D407-667-105TRN
Job Sheet 173568

Part Name: Crosstube Turning Detail

DRAWING NO. D407-667-145	TITLE CROSSTUBE ASS'Y (407 HIGH FWD)	REV. C	DART AEROSPACE LTD ENGINEERING ORDER		D.E.O. NO. D407-667-145-C-1	SHEET NO. SHEET 1 OF 1	SCALE NTS
DRAWN <i>qp</i>	CHECKED <i>ASS</i>	MFG. APPR. <i>ASS</i>	APPROVED <i>WD</i>		DE APPR. <i>WD</i>		
DATE 11.07.15	DATE 11.07.22	DATE 11.07.22	DATE 11/07/22		DATE 11.07.21

DRAWING NO. D407-667-145	TITLE CROSSTUBE ASS'Y (407 HIGH FWD)	REV. C	DART AEROSPACE LTD ENGINEERING ORDER	D.E.O. NO. D407-667-145-C-2	SHEET NO. SHEET 1 OF 1	SCALE NTS
DRAWN AJS	CHECKED <i>[Signature]</i>	MFG. APPR. <i>[Signature]</i>	APPROVED <i>[Signature]</i>	DE APPR. <i>[Signature]</i>		
DATE 12.08.02	DATE 12.08.02	DATE 12.08.02	DATE 12.08.02	DATE 12.08.02	DATE 12.08.02

DETAIL P
BONDING STRAP INSTALLATION 2 PL

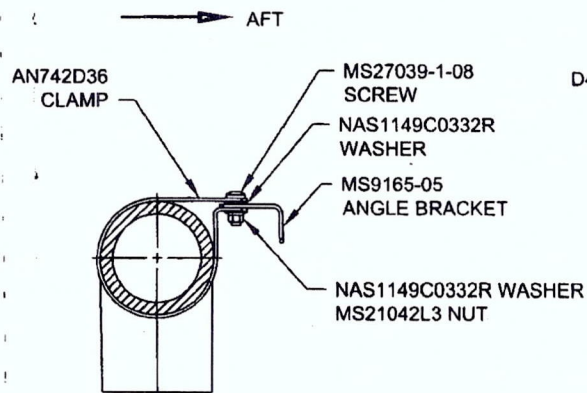
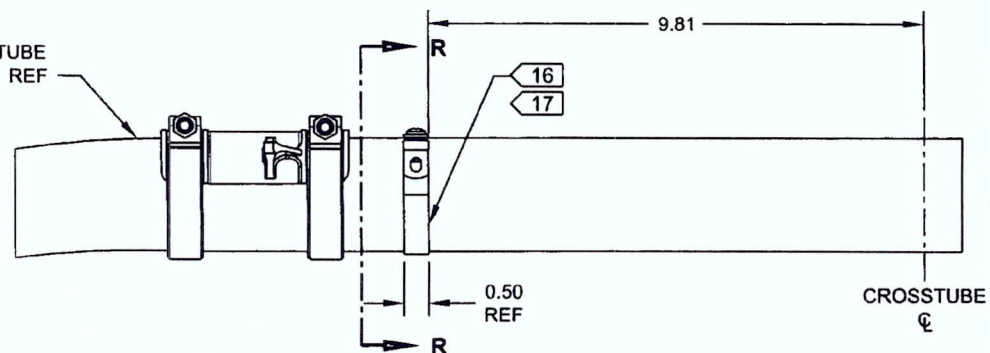
ADD ELECTRICAL GROUNDING STRAP

ITEM	QTY -145	PART NUMBER	DESCRIPTION
1	X	D407-667-145	CROSSTUBE ASSEMBLY (407 HIGH FWD)
10	2	AN742D36	CLAMP
11	2	MS9165-05	ANGLE BRACKET
12	2	MS21042L3	NUT (OR MS21042-3)
13	2	MS27039-1-08	SCREW
14	4	NAS1149C0332R	WASHER (OR AN960C10L)

- 16) MASK AREA UNDER CLAMP PRIOR TO PAINTING
- 17) SEAL EDGES WHERE AN742D36 CLAMP MEETS WITH THE CROSSTUBE USING SIKAFLEX-241/-291 OR MIL-S-8802 CLASS B2 OR PROSEAL 890 SEALANT
- 18) PERFORM RESISTANCE CHECK TO ENSURE MAX RESISTANCE IS 10 MLLIOHMS
